CITY OF MANHATTAN BEACH COMMUNITY DEVELOPMENT DEPARTMENT STAFF REPORT

SUBJECT: Coastal Development Permit Amendment to Allow Larger Concrete Pads for

Maintenance Vehicle Parking above an Underground Storm Drain Low-Flow Diversion Project on the Public Beach between 27th Street and 28th Street (Los

Project No. 286 – Low Flow Diversion

Figure 3 – As-built condition of Project No. 286

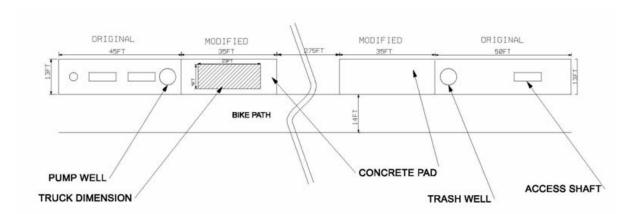
Due to the heavy pedestrian traffic on the Strand (bicyclists, runners, rollerbladers, etc. – See Appendix for traffic counts) it was determined based on field inspection that a staging area for maintenance crews would be needed to prevent any obstruction of the Strand. DPW has deemed any obstructions to the Strand as a hazard to public safety therefore concrete pads were constructed around the Low Flow Diversion units.

The concrete pad on 28th Street and The Strand is 13 feet by 85 feet and the pad on 27th and The Strand is 13 feet by 80 feet. Upon further review of these dimensions, it has been determined that the pads on 27th and 28th can be reduced by 4 and 9 feet respectively. This is the minimum length required to safely maneuver and operate the vacuum truck and its support vehicle. This minimum length was determined by placing both vehicles end-to-end and measuring the excess concrete on the pads. If deemed necessary, those excess portions of concrete can be removed.

- 9. The final construction shall be in substantial conformance with the plans for the overall project as approved by the Planning Commission on October 26, 2005 except that the southerly concrete pad shall be permitted to be 76 feet long (4 feet less than existing), and the northerly concrete pad shall be permitted to be 76 feet long (9 feet less than existing).
